## Providence Bicycle and Pedestrian Advisory Commission

### **Staff Report: Waterman Street Restriping –Wayland (For Action)**

*Presented at May 18, 2016 BPAC meeting*

#### **Project Map**

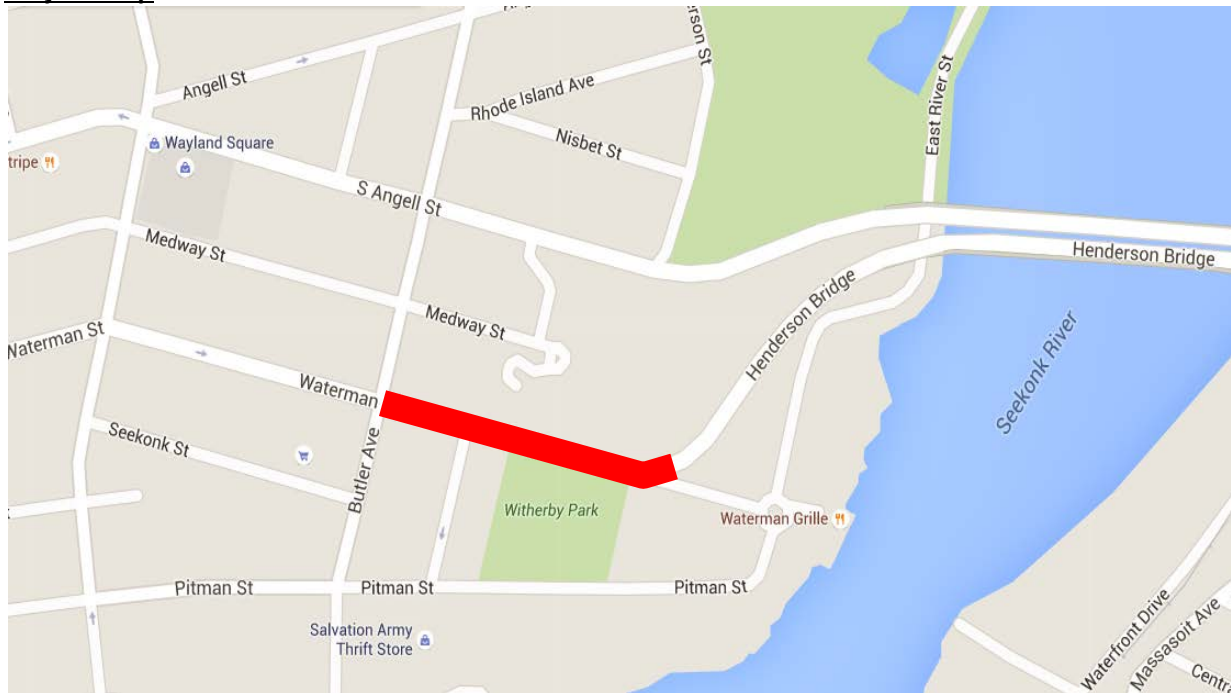
- The City should consider installing a stop sign prior to the new crosswalk at the base of the Henderson Bridge in order to improve the safety of pedestrians crossing the street and reduce the speed of traffic.
